**AGENDA ITEM: 3. Site Plan Review – 919 Shives Road**

On March 22<sup>nd</sup>, the Community Development Department received a request from VEH Frontenac LLC for construction of a retail center at 919 Shives Road. The proposed retail center is part of a larger development which potentially includes a hotel and a restaurant use/building (Attachment A). However, due to timelines for closing on the other properties involved with the larger development, a site plan was submitted only for the retail center.

City staff has received and reviewed the site plan submittal for a retail center at 919 Shives Road. At this time site plan approval is denied, pending the items listed below:

SHEET 4 OF 10 SHEETS

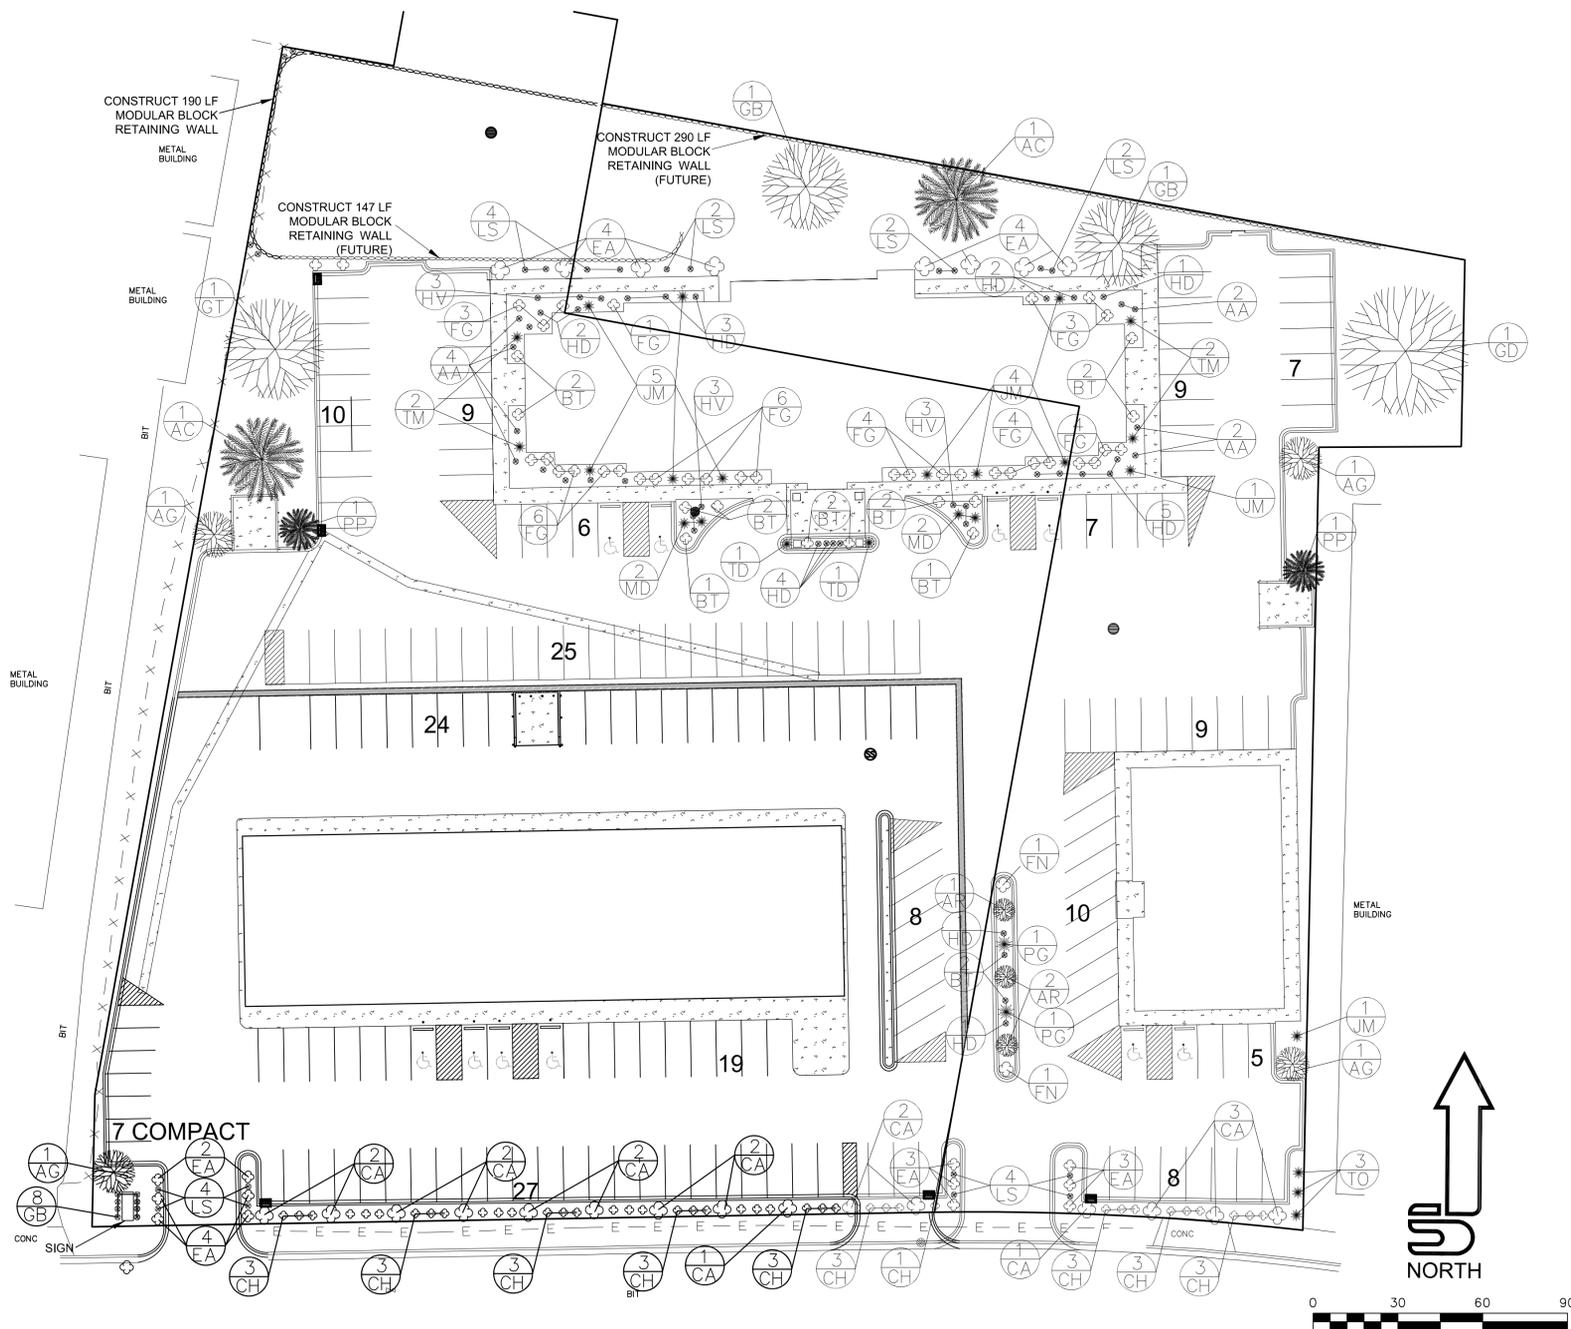
- All trash enclosures will be constructed to a minimum height of 6 feet (Sheet 4 Notes-Revised Plans 4/4/2016).
- On-site lighting will not exceed a height of 30 feet, and will employ full cut-off style lights (Sheet 4 Notes-Revised Plans 4/4/2016).

## HYDROLOGY PLAN

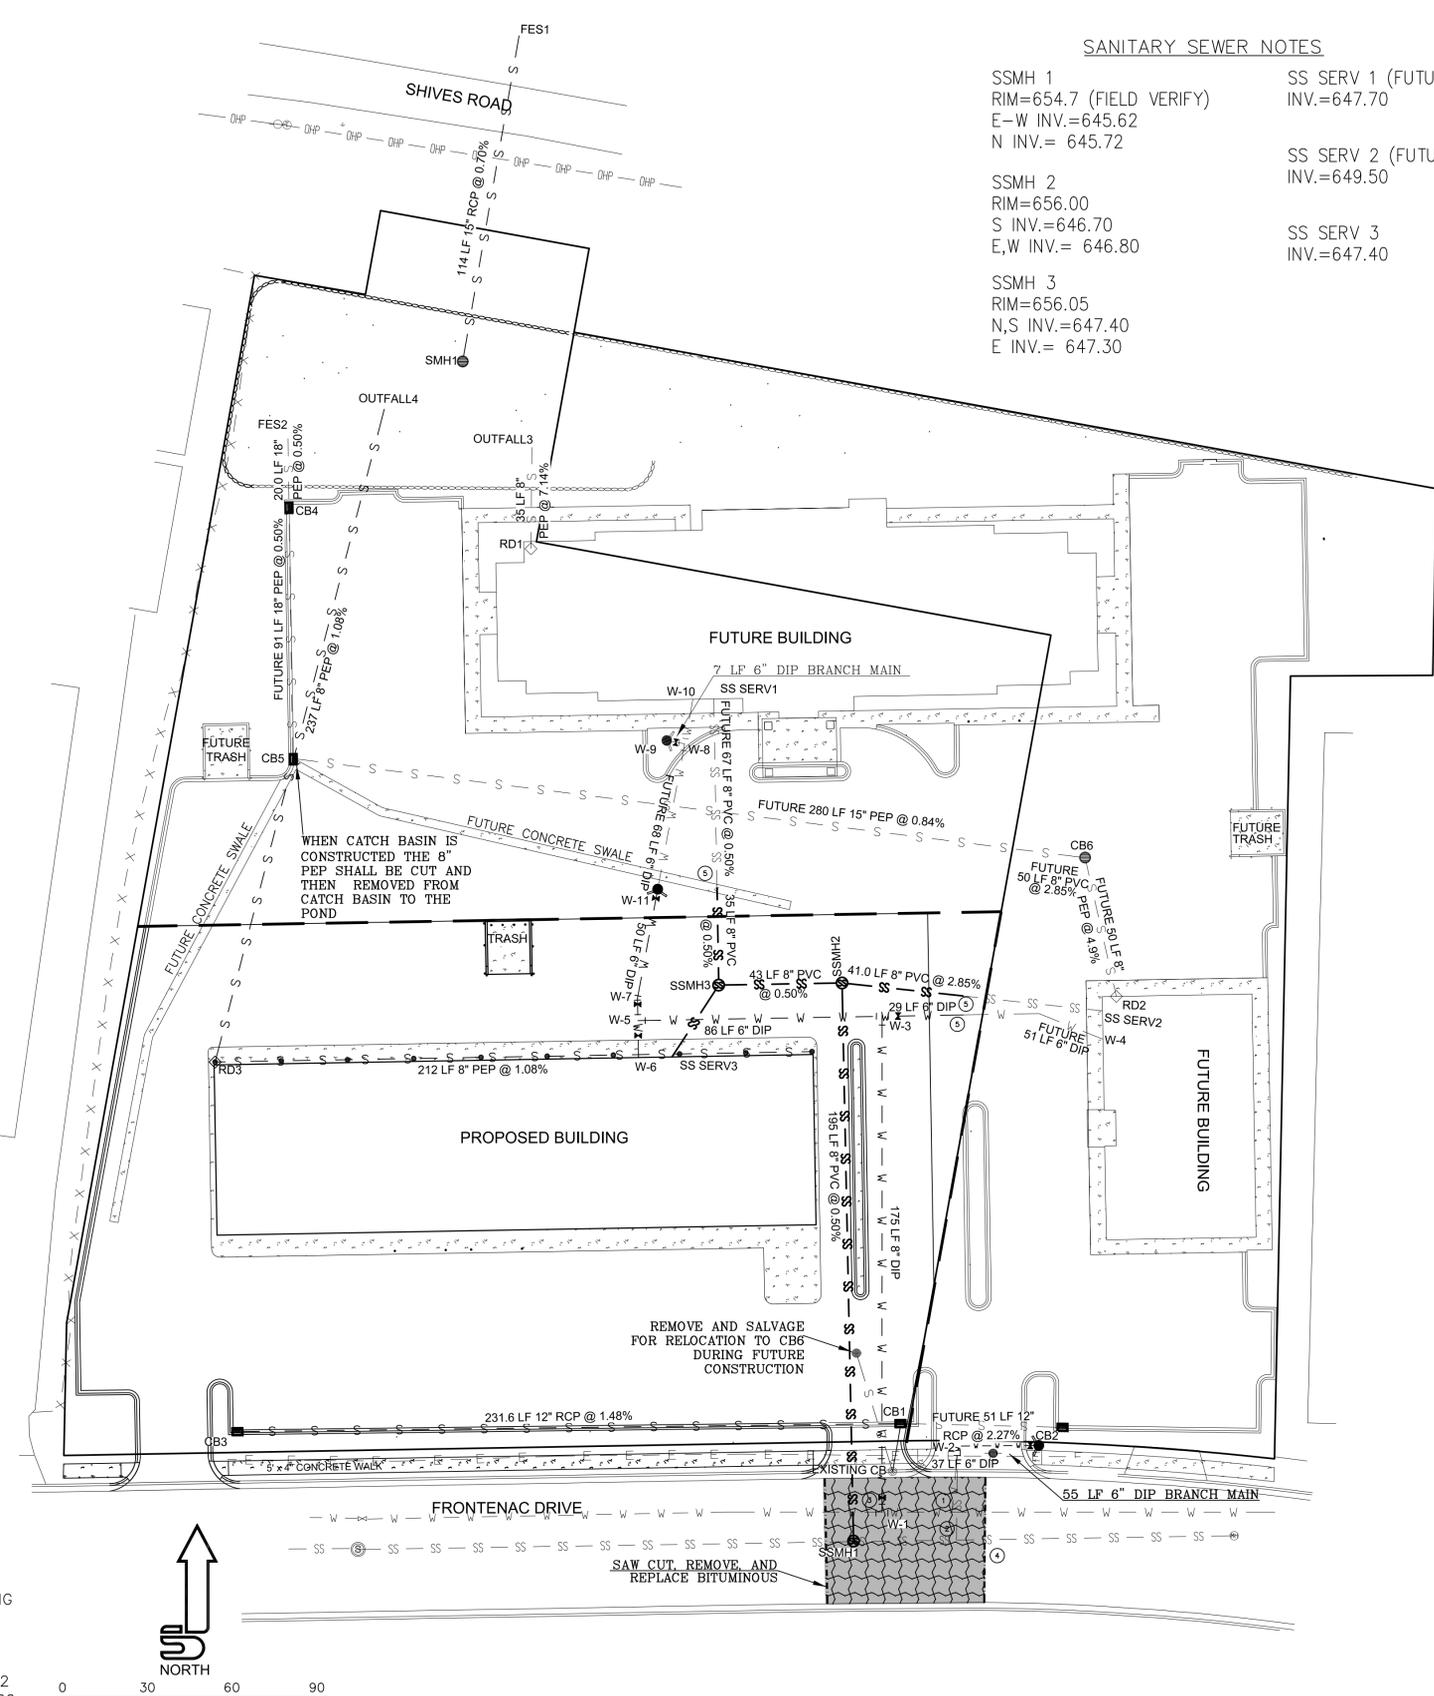
5. Please examine contours to the north of proposed building on the Hydrology Plan and correct as appropriate.
6. The westerly sanitary sewer shown on the Utility Plan needs to be removed. Please reference attachment one to this letter.

**UTILITY AND STREET REPAIR PLAN**  
SHEET 6 OF 10 SHEETS

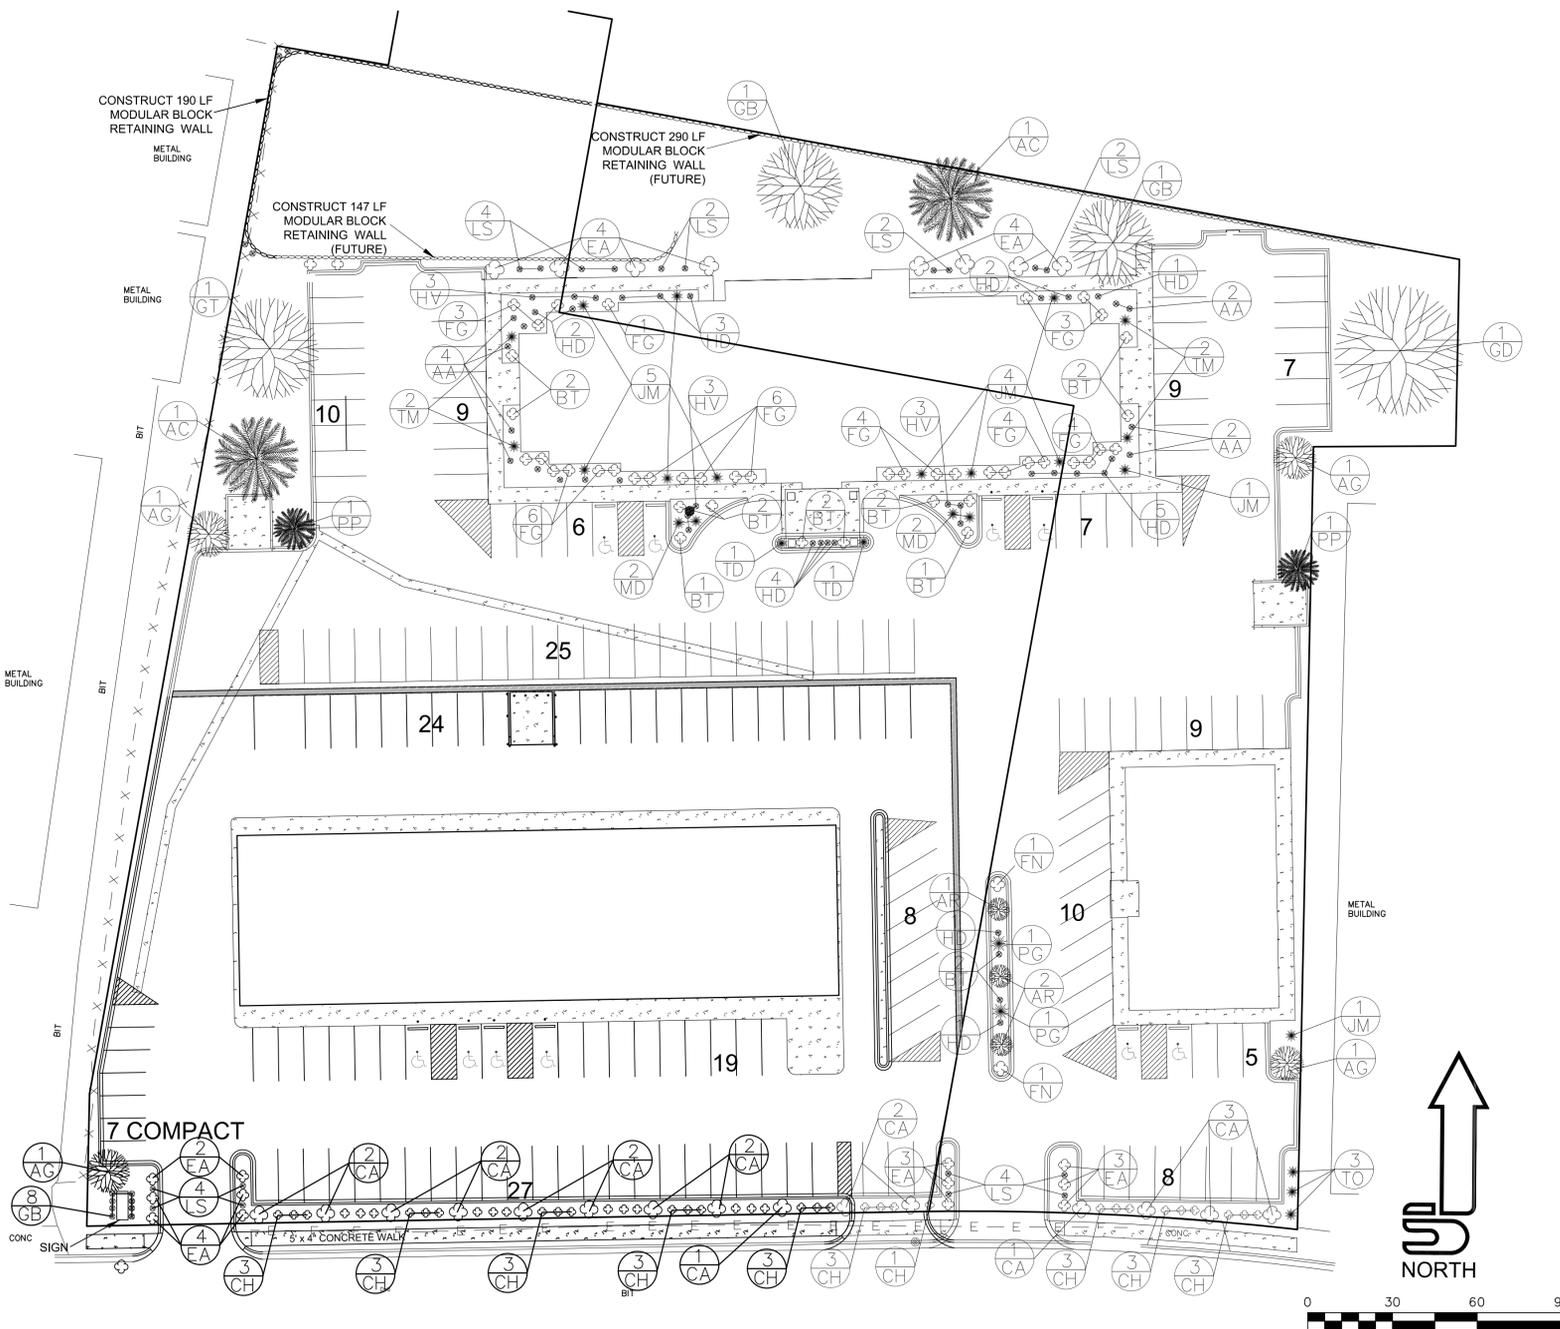
8. Three additional water valves must be added in the locations shown on attachment one. In addition, consider an 8" water line connection to the main. Contact Bob Dunn in the Water Department with questions at 457-8270.

9. W-2 may be eliminated and the existing connection to the water main used as shown in attachment one. Contact Bob Dunn in the Water Department with questions at 457-8270.

- W-1  
F&I 8" WET TAP  
F&I 8" GATE VALVE
- W-2  
F&I 6" 90° BEND  
F&I 37 LF 6" DIP BRANCH MAIN  
INSTALL HYDRANT AND VALVE
- W-3  
F&I 6"x6"x8" TEE  
F&I 6" GATE VALVE
- W-4 (FUTURE)  
F&I CORPORATE VALVE  
CONNECT TO BUILDING  
VERIFY LOCATION WITH  
MECHANICAL PLANS  
F&I 22 1/2' BEND
- W-5  
F&I 6"x6"x6" TEE  
F&I 6" GATE VALVE
- W-6  
F&I CORPORATE VALVE  
CONNECT TO BUILDING  
VERIFY LOCATION WITH  
MECHANICAL PLANS
- W-7  
F&I 6"x11 1/4' BEND  
F&I 6" GATE VALVE
- W-8 (FUTURE)  
F&I 6"x6"x6" TEE
- W-9 (FUTURE)  
F&I 6" GATE VALVE  
F&I HYDRANT
- W-10 (FUTURE)  
F&I CORPORATE VALVE  
CONNECT TO BUILDING  
VERIFY LOCATION WITH  
MECHANICAL PLANS
- W-11  
F&I 6" GATE VALVE  
F&I HYDRANT  
(TO BE RELOCATED TO W-9  
DURING FUTURE EXPANSION)

- 1 EXISTING 6" WATER FEED SERVICE TO BE USED TO CONNECT TO NEW HYDRANT & GATE VALVE PER CITY OF WINONA STANDARDS.
- 2 EXISTING SANITARY SERVICE TO BE REMOVED AND CAPPED TO RIGHT OF WAY PER CITY OF WINONA STANDARDS
- 3 A WET TAP WILL BE REQUIRED
- 4 THE DEVELOPER SHALL SUBMIT FOR APPROVAL A TRAFFIC CONTROL PLAN TO THE CITY OF WINONA PRIOR TO STREET CLOSURE FOR THE SANITARY AND WATER UTILITY PIPE CONNECTIONS.
- 5 END AND GAP PIPE 10 FEET PAST EDGE OF PAVEMENT
